June 17, 2011

#### ALAMEDA ISLANDER MOTEL 2428 CENTRAL AVENUE ALAMEDA, CALIFORNIA

# REVISED SITE CONCEPTUAL MODEL AND ADDITIONAL SITE ASSESSMENT WORKPLAN

On behalf of the City of Alameda, Strategic Engineering & Science is submitting this Revised Site Conceptual Model and Additional Site Assessment Workplan for the Alameda Islander Motel located at 2428 Central Ave in Alameda, California. This document was revised in accordance with the recommendations made by Alameda County Environmental Health during the June 15, 2011 meeting at the project site, based on their review of documentation regarding tank locations. The following changes have been made:

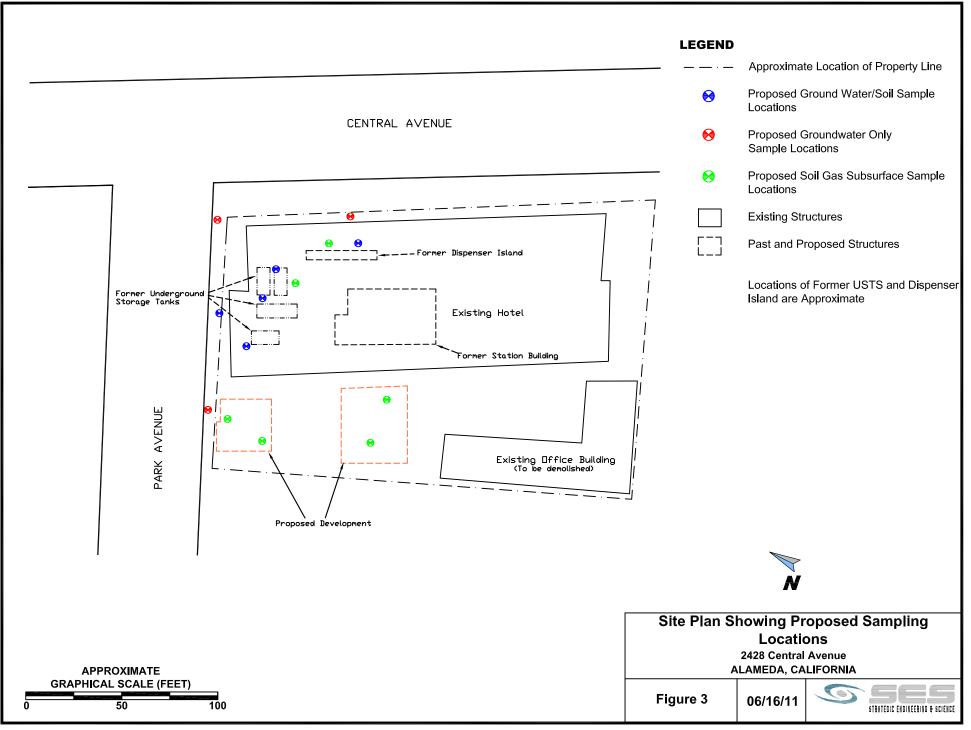
- 1. The location of the former fuel stations facilities (underground storage tanks, dispensers and office) was revised in accordance with the 1936 station map provided by ACEH.
- 2. Eight borings (including two soil vapor samples) were relocated as a result of the new station facility information.
- 3. Two (2) additional soil vapor sample locations were added; one to each proposed new building footprint.
- 4. The soil vapor sampling depth was lowered from 3.5 feet below grade to 4.

Eight (8) direct-push soil borings will be advanced at the locations depicted in Figure 3. The borings will be advanced to approximately 5 feet below grade or to the top of the first water bearing zone, which is anticipated to be encountered from 5 to 10 fbg.

SES will collect six (6) soil gas samples at the location of the proposed new construction area on the northwestern portion of the Site and at the location of the former USTs and former dispenser island. Sample locations are shown on Figure 3. The samples will be collected from the subsurface by direct-push sampling techniques using a truck-mounted direct-push rig. Sample will be collected from a depth of approximately 4½ fbg. General field procedures to be followed during this investigation are detailed in Appendix C.
